Access Compliance Report

Public Rights-of-Way

(Curb Ramps)

Intersection ID: 11920	Main Street: FREEDOM_DR	Cross Street: WOODRUFF_PL	Location: S
ADA ID: 0E4C2AC01298	Ramp Type: Perp	Initial Pass/Fail: Fail	Overall Compliance: No
Severity Score: 8.75			
Codes/Mitigation Info/Possible Solution		Field Measurements/Component Compliance

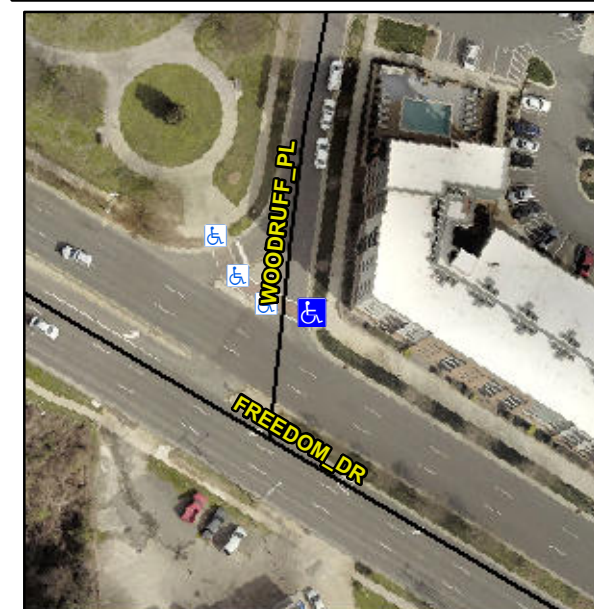
Not Found, R304.5.1

Compliance	Description	Data	Compliance	Description	Data
N/A	Ramp Length (in)	71.0	Yes	Ramp Slope (%)	5.1
No	Ramp Width (in)	42.0	Yes	Ramp XSlope (%)	1.4
N/A	Flare Type LT	N/A	N/A	Flare Type RT	N/A
N/A	Flare Slope LT (%)	N/A	N/A	Flare Slope RT (%)	N/A
N/A	Flare Traversable LT?	N/A	N/A	Flare Traversable RT?	N/A
N/A	Landing Length (in)	N/A	N/A	DWS Provided?	N/A
N/A	Landing Width (in)	N/A	N/A	DWS Contrast?	N/A
N/A	Landing Slope (%)	N/A	N/A	DWS Length (in)	N/A
N/A	Landing X Slope (%)	N/A	N/A	DWS Full Width?	N/A
N/A	Landing Curb? (Y/N)	N/A	N/A	DWS Offset (in)	N/A
N/A	Shared Landing?	N/A			
N/A	Gutter Ponding?	N/A	N/A	Gutter Slope (%)	N/A
N/A	Gutter Lip Ht (in)	N/A	N/A	Gutter X Slope (%)	N/A
N/A	Painted X Walk1?	Yes	N/A	Painted X Walk2?	N/A
	X Walk 1 Direction	To NW		X Walk 2 Direction	N/A
N/A	X Walk 1 Width (in)	92.0	N/A	X Walk 2 Width (in)	N/A
	X Walk 1 Slope (%)	3.0		X Walk 2 Slope (%)	N/A
	X Walk 1 X Slope (%)	2.7		X Walk 2 X Slope (%)	N/A

Remove & Replace Entire Ramp.
